Our ref: Q080666 el/jn
Your ref: 20/00293/OUT
Email: emma.lancaster@quod.com
Date: 17 June 2020

Application Ref: 20/00293/OUT – Bicester Gateway Phase 1B

Executive Summary

Figure 1 Applicant's proposed substandard crossing on Charles Shouler Way

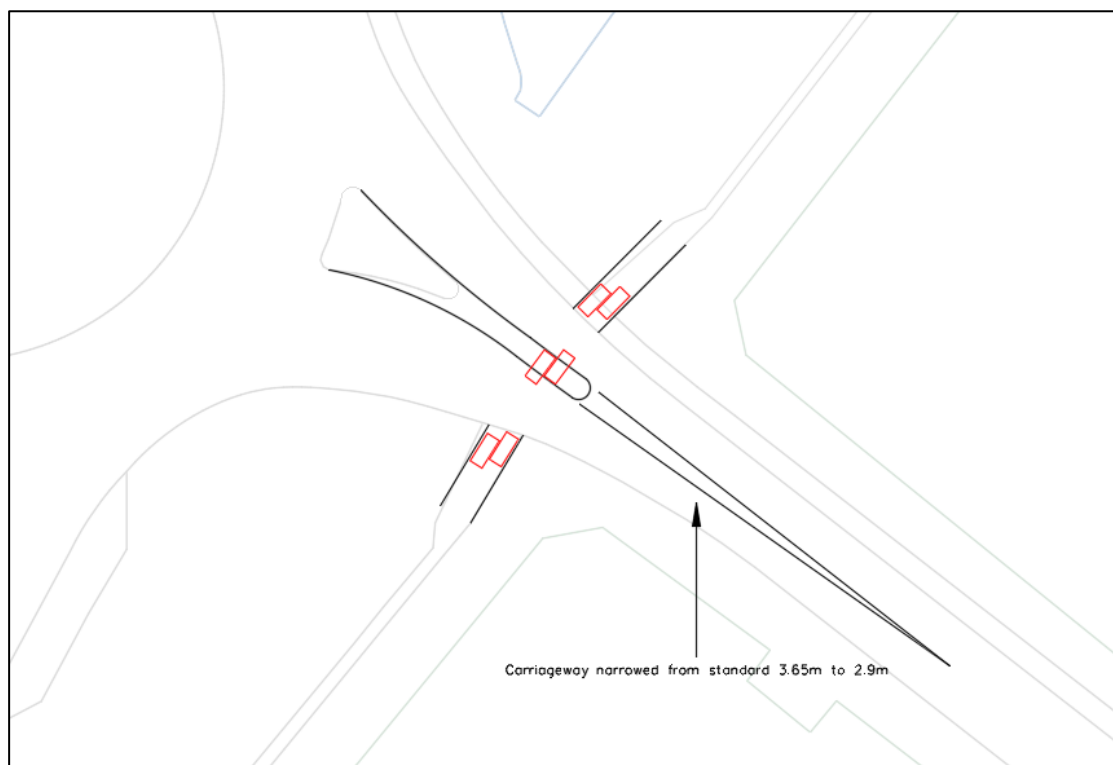
18. The cycling design vehicle for cycle crossings as set out in CD195 is 2.8m long and 1.2m wide (red boxes on **Figure 1** above). This is reflected in the design of the refuges at the Phase 2 site access roundabout which are 3.0m long and 3.0m wide where two-way cycle movements can therefore be fully accommodated.

19. In contrast the proposed Phase 1B refuge at 2.0m is insufficiently long to accommodate the cycling design vehicle.
20. The visibility requirements for a cycle crossing as per CD195 para E/3.5 are based on a desirable minimum setback of 4.5m and an absolute minimum setback of 2.4m. The Y distance whilst in DMRB terms would relate to CD123 in practice it would be more typical to adopt MfS2 parameters. Whilst the link is derestricted it is likely that speeds will be constrained to 60kph i.e. a Y distance of 59m. These splays must be secured free from obstruction (including rearrangement of headwall fencing).

21. The introduction of the splitter island is contrary to CD116 introducing sub-standard geometry. This compromises highway capacity and safety of the A41-Vendee Drive roundabout.

22. Whilst the channelization of the exit is not ideal and increases the risk of blocking back onto the circulatory carriageway (contrary to CD116 para 3.28.1-3) the greater design issues relate to the entry as the refuge is built out into the existing westbound lanes.

24. It is proposed to reduce the westbound lane width from 3.65m to circa 2.9m as a result of the extension of the central splitter island. There is no justification for narrow lanes which will be detrimental to safety and likely to result in damage to infrastructure, damage to vehicles particularly HGV and to buses and over-running of the pedestrian crossings. This could be addressed by commensurate widening of Charles Shouler Way so that a minimum lane width of 3.65m is maintained (whilst ensuring that entry path curvature is maintained).
